3/4.1 REACTIVITY CONTROL SYSTEMS

3/4.1.2 BORATION SYSTEMS

3/4.4 REACTOR COOLANT SYSTEM

3/4.4.9 PRESSURE/TEMPERATURE LIMITS

FIGURE 3.4.9-1

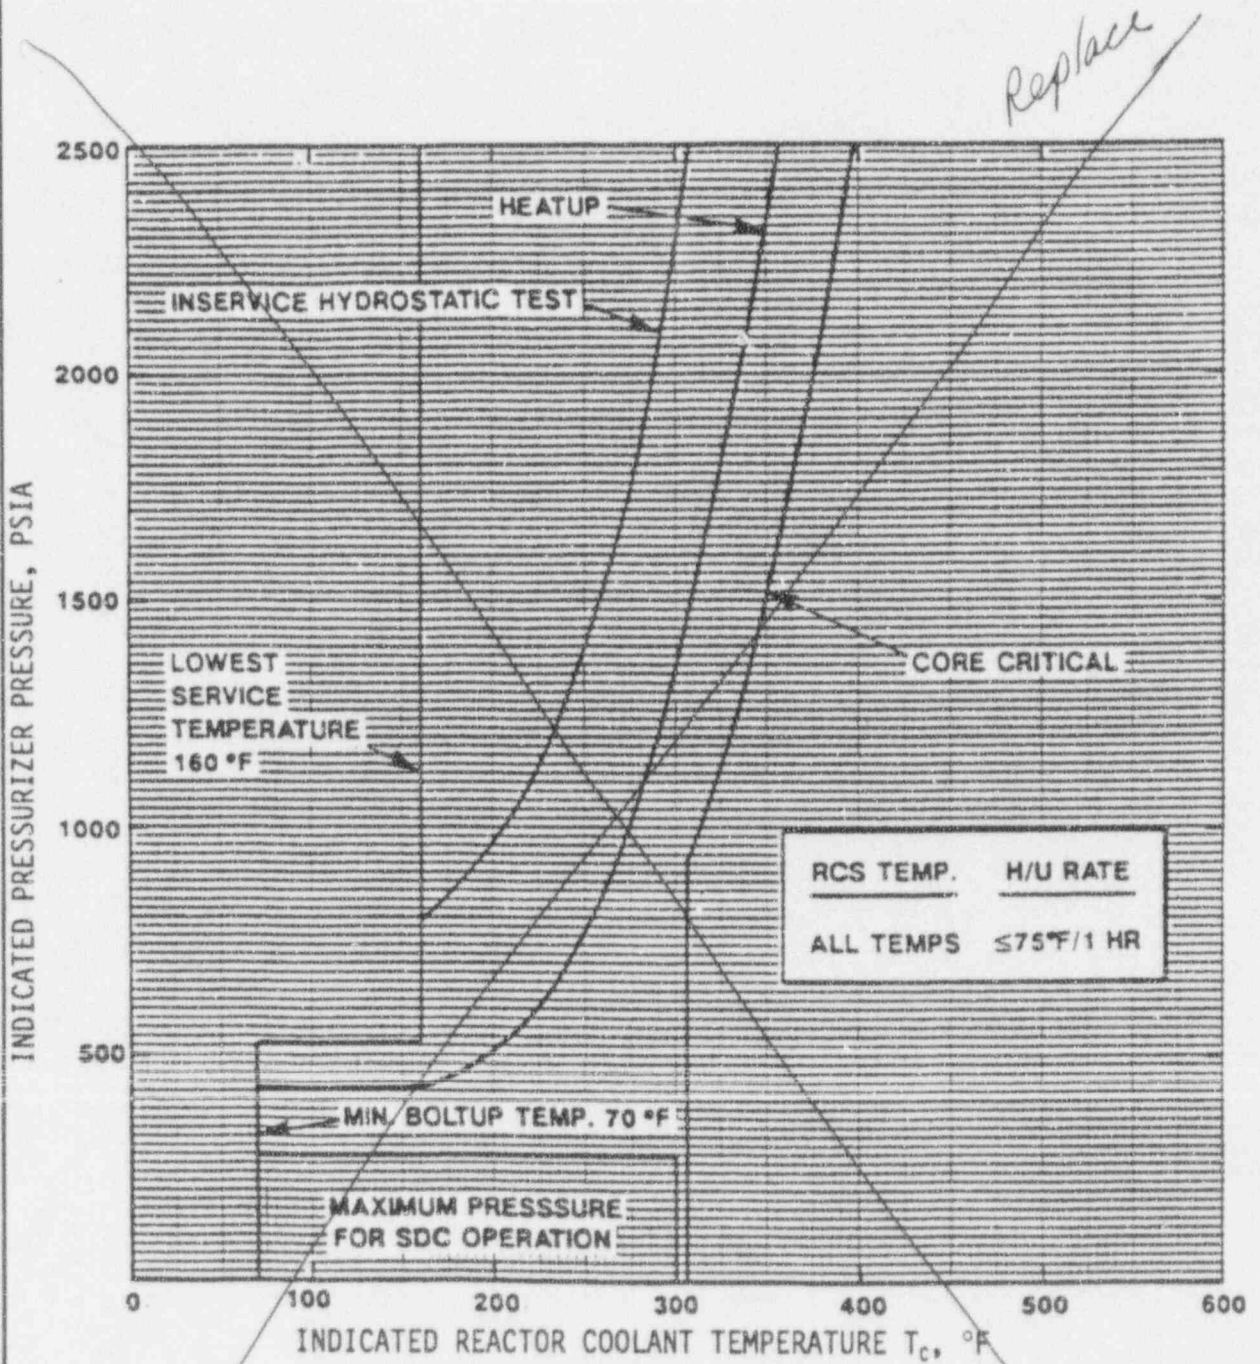
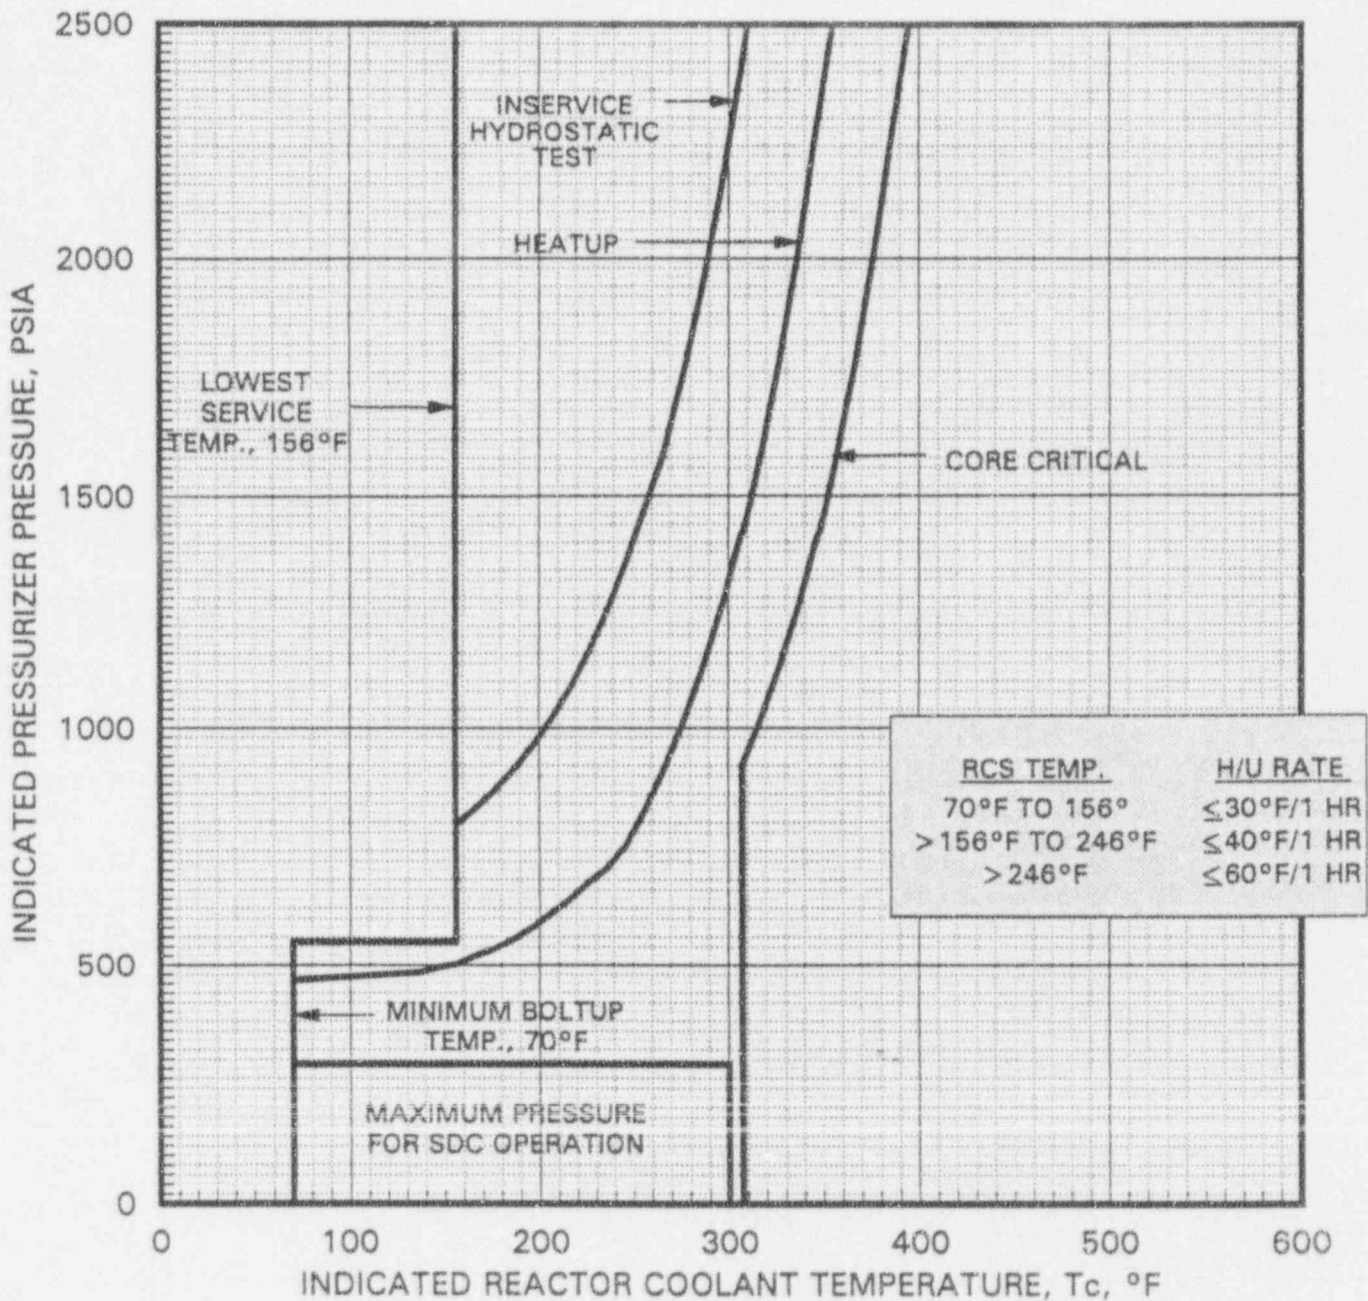
CALVERT CLIFFS UNIT 2 HEATUP CURVE, for FLUENCE $\leq 1.92 \times 10^{19}$ n/cm²
 REACTOR COOLANT SYSTEM PRESSURE TEMPERATURE LIMITS

CALVERT CLIFFS UNIT 2 HEATUP CURVE, FOR FLUENCE $\leq 4.0 \times 10^{19} \text{ n/cm}^2$
REACTOR COOLANT SYSTEM PRESSURE TEMPERATURE LIMITS

FIGURE 3.4.9-2

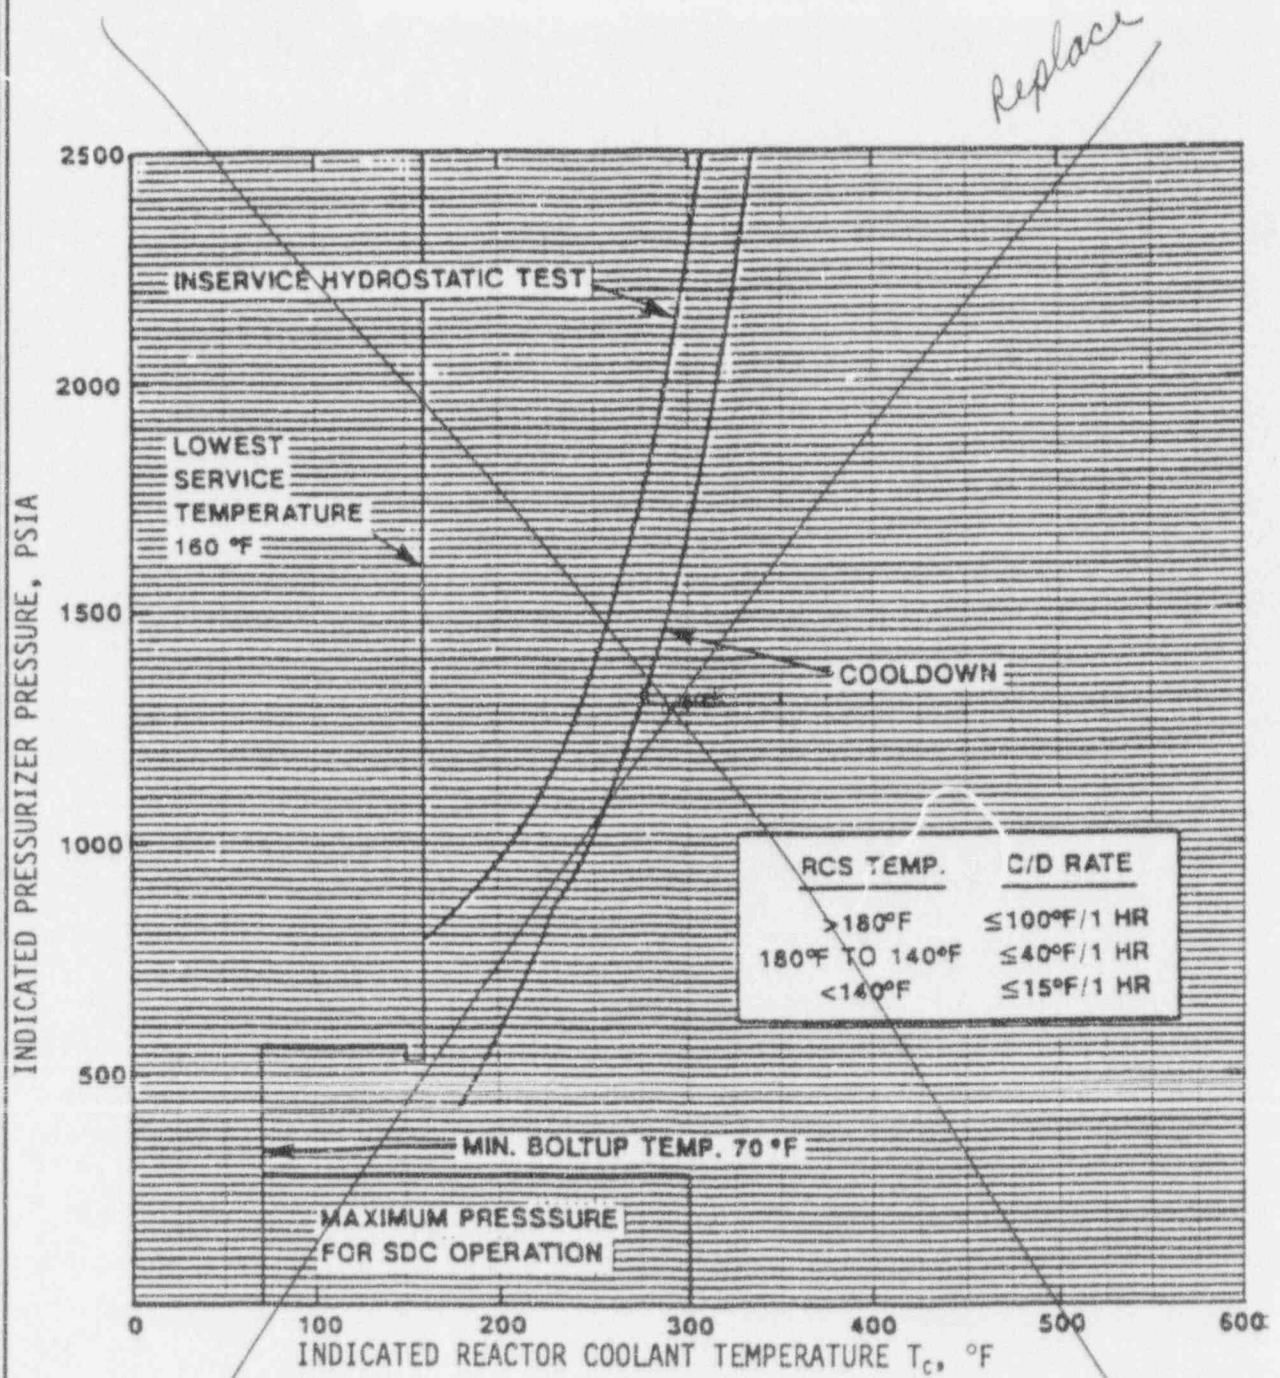
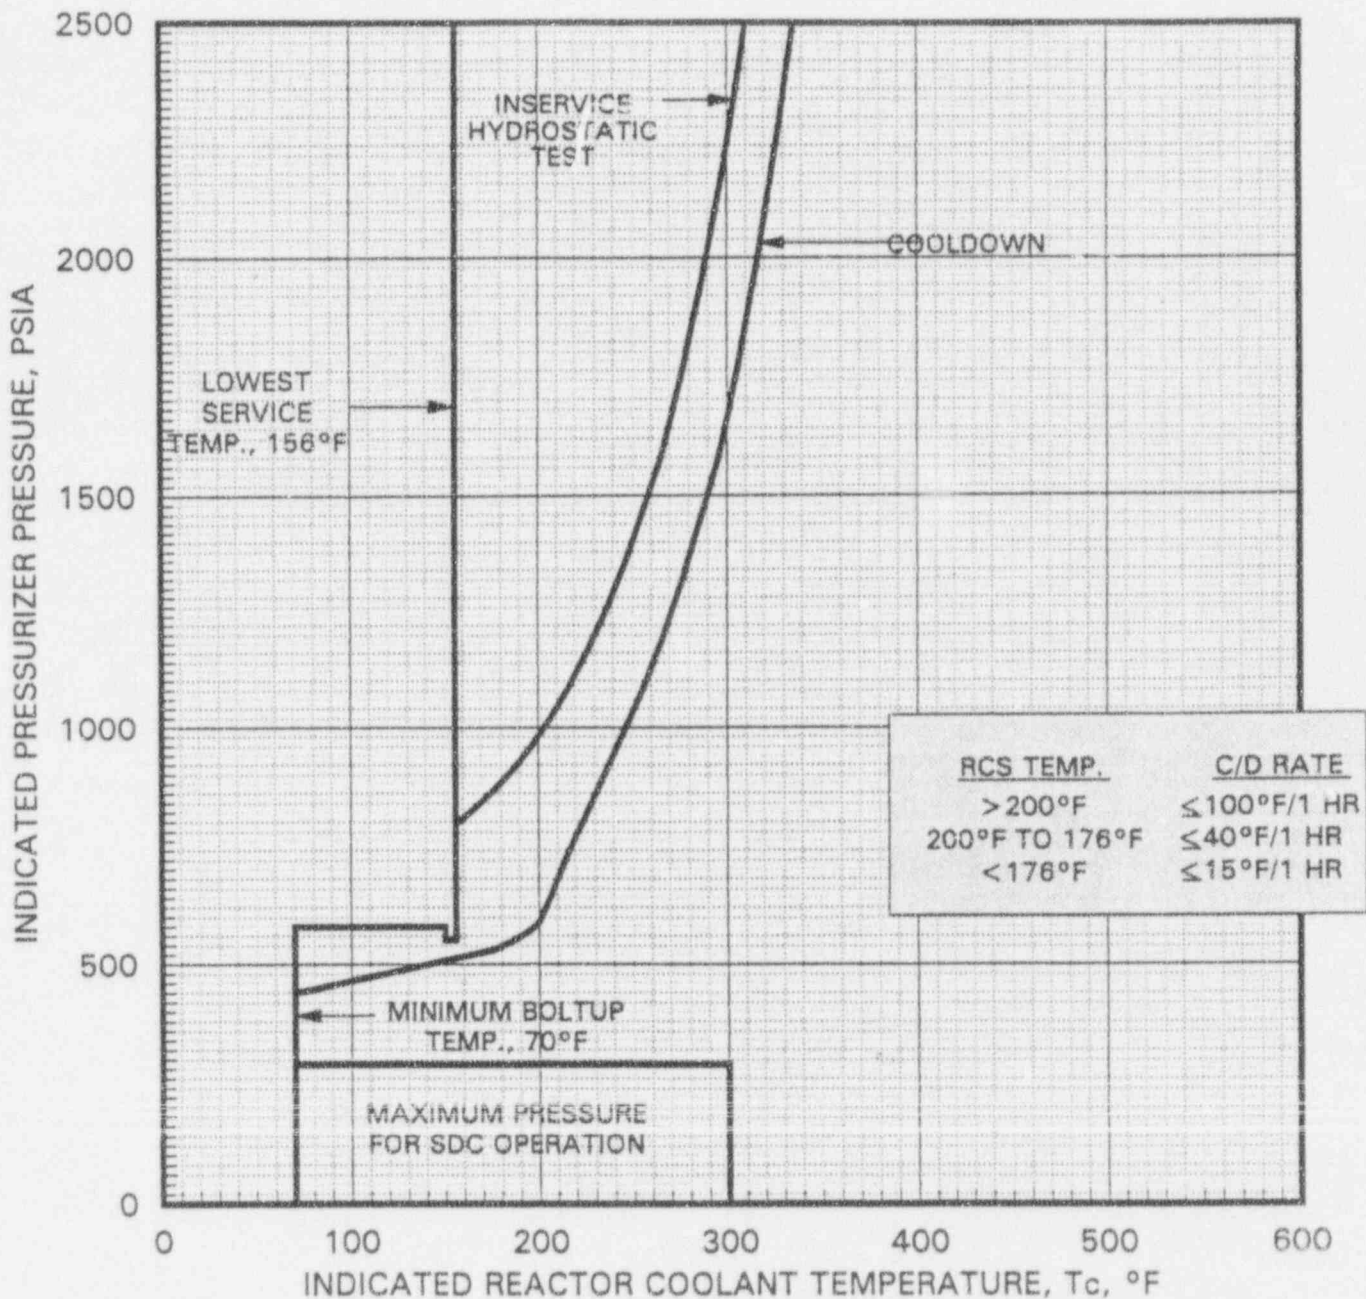
CALVERT CLIFFS UNIT 2 COOLDOWN CURVE, for FLUENCE $\leq 1.92 \times 10^{19}$ n/cm²
 REACTOR COOLANT SYSTEM PRESSURE TEMPERATURE LIMITS

CALVERT CLIFFS UNIT 2 COOLDOWN CURVE, FOR FLUENCE $\leq 4.0 \times 10^{19}$ n/cm²
REACTOR COOLANT SYSTEM PRESSURE TEMPERATURE LIMITS

FIGURE 3.4.9-3
 CALVERT CLIFFS UNIT 2, FOR FLUENCE $\leq 4.0 \times 10^{19}$ n/cm²
 MAXIMUM PORV OPENING PRESSURE vs TEMPERATURE

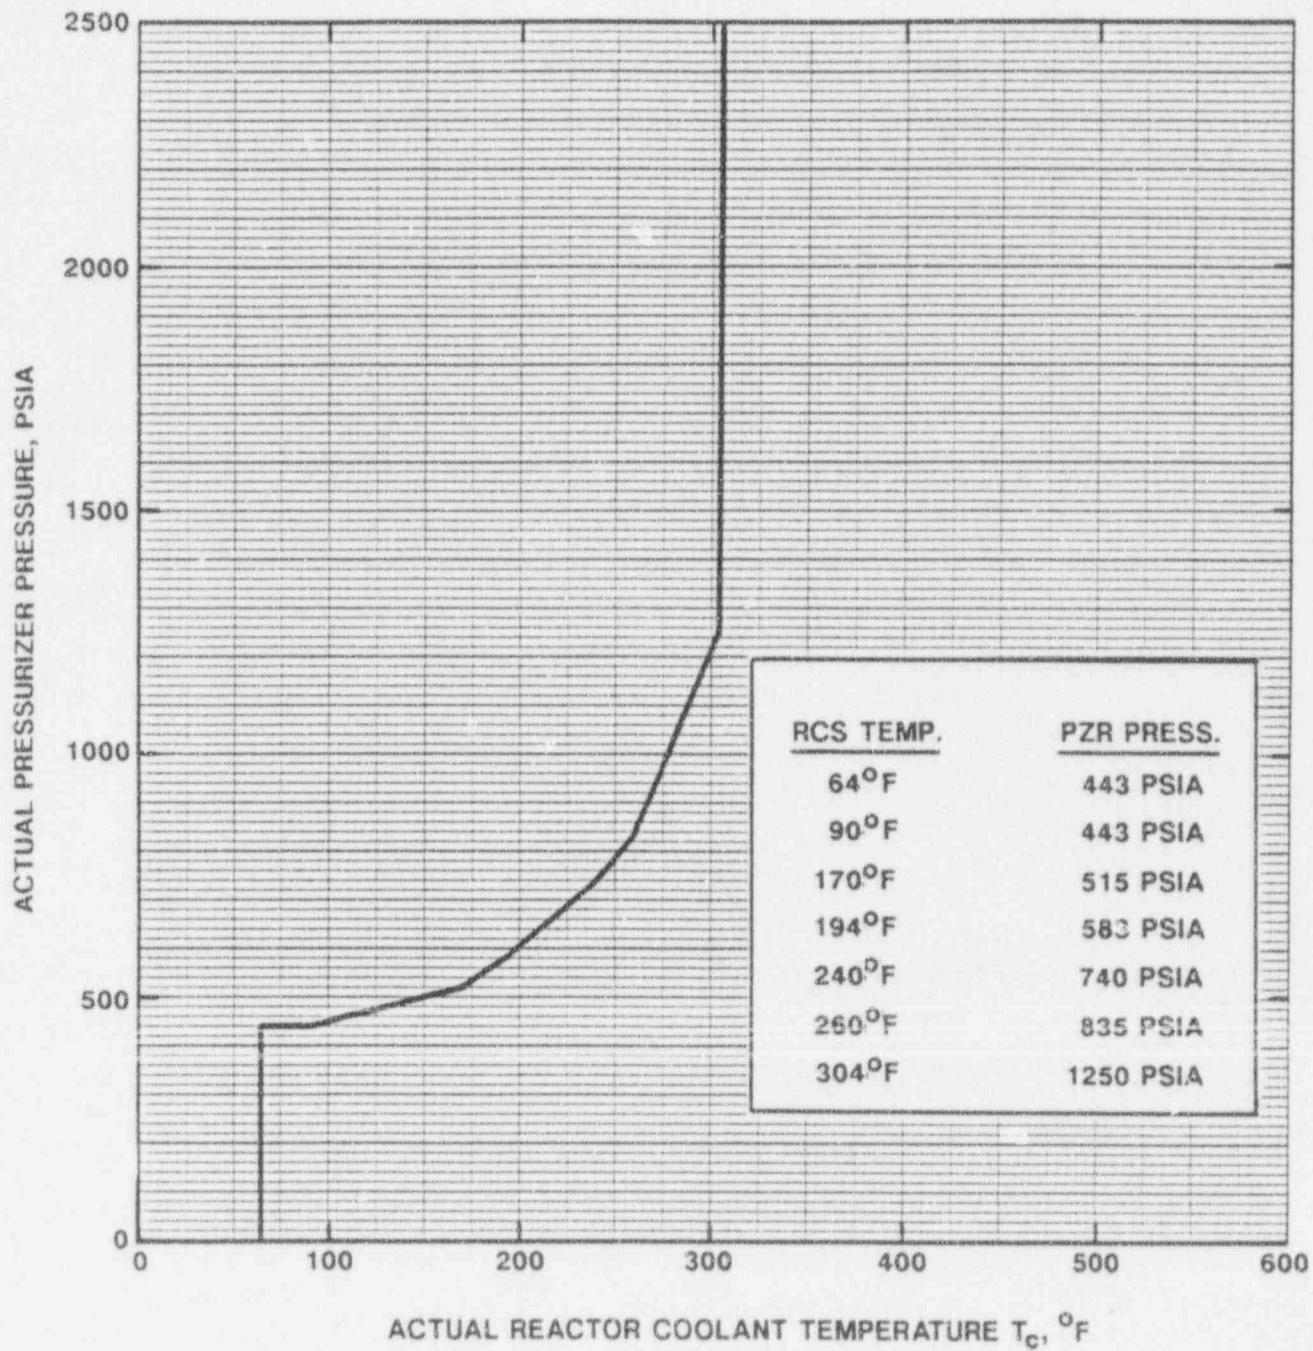
- a. One of the following three overpressure protection systems shall be in place:
 1. Two power-operated relief valves (PORVs) with a lift setting ^{below the curve in Figure 3.4.9-5*} of ≤ 430 psia with their associated block valves open, or ^{TRIP setpoint} ~~lift setting~~ ^{TRIP setpoint}

The PORV setpoint is chosen to protect the most limiting of the heatup or cooldown Appendix G limits. Figure 3.4.9-3 shows the maximum PORV opening pressure. This includes corrections for static and dynamic head, and pressure overshoot to account for PORV response time and the maximum pressurization rate. The actual PORV setpoint and the MPT Enable setpoint are controlled by procedure and account for all associated uncertainties.
